Re: Collin County Medical & Mental Health

Subject: CO #092 –RFI 264 - Shifted CMU Wall to Accommodate DST01D (RFI #264)

PROJECT: Collin County Mental Health Expansion

264 - DST01D Oversized Frame

A237

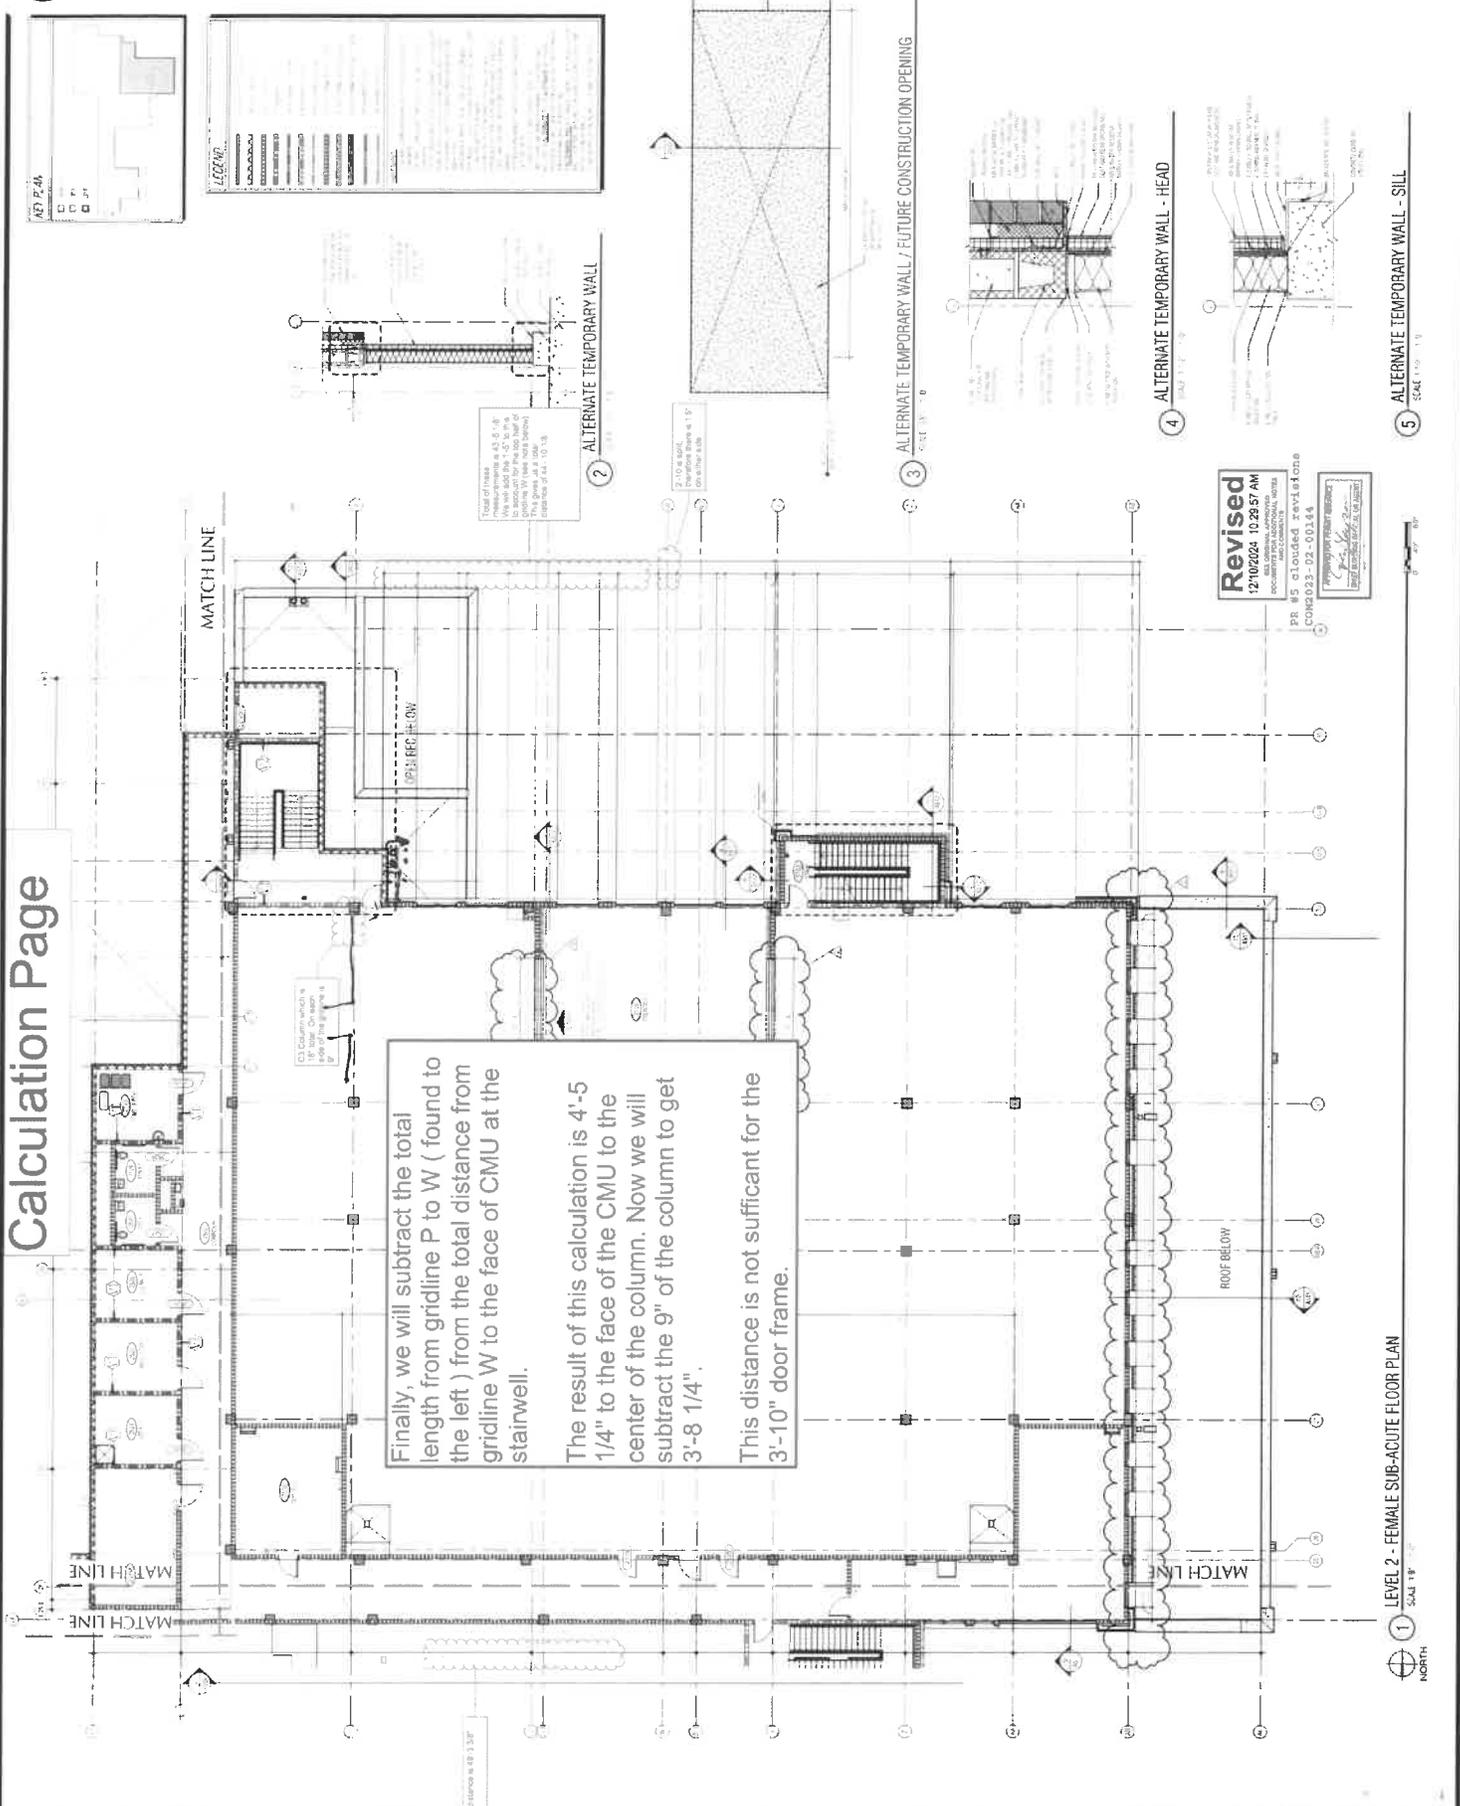
According to the attached detention door schedule D702, DST01D is shown to be 3'-10" in width. Sheet A237 only shows this doorway to be 3'-8 1/4" wide, not leaving enough room to place the door frame. See the attached document for the calculations that arrived at this number. While the surrounding CMU wall has already been installed up to 4', it can still be demoed and repositioned plan view south 8" to accommodate this oversized frame. To do this the roof drains at the low roof of 1300 will have to be shifted as well. See the attached sketch on sheet A237 depicting this shift. Advise if the repositioning of the CMU wall and roof drains are acceptable.

Finally, we will subtract the total length from gridline P to W (found to the left) from the total distance from gridline W to the face of CMU at the stairwell.

The result of this calculation is 4'-5 1/4" to the face of the CMU to the center of the column. Now we will subtract the 9" of the column to get 3'-8 1/4".

This distance is not sufficient for the 3'-10" door frame.

The proposed solution is acceptable however if there is cost involved then submit pricing prior to proceeding. A send option is to shift the door plan south to fit within the opening. This ~2" shift will not be ideal but will still be acceptable. This stair door will not be used frequently.
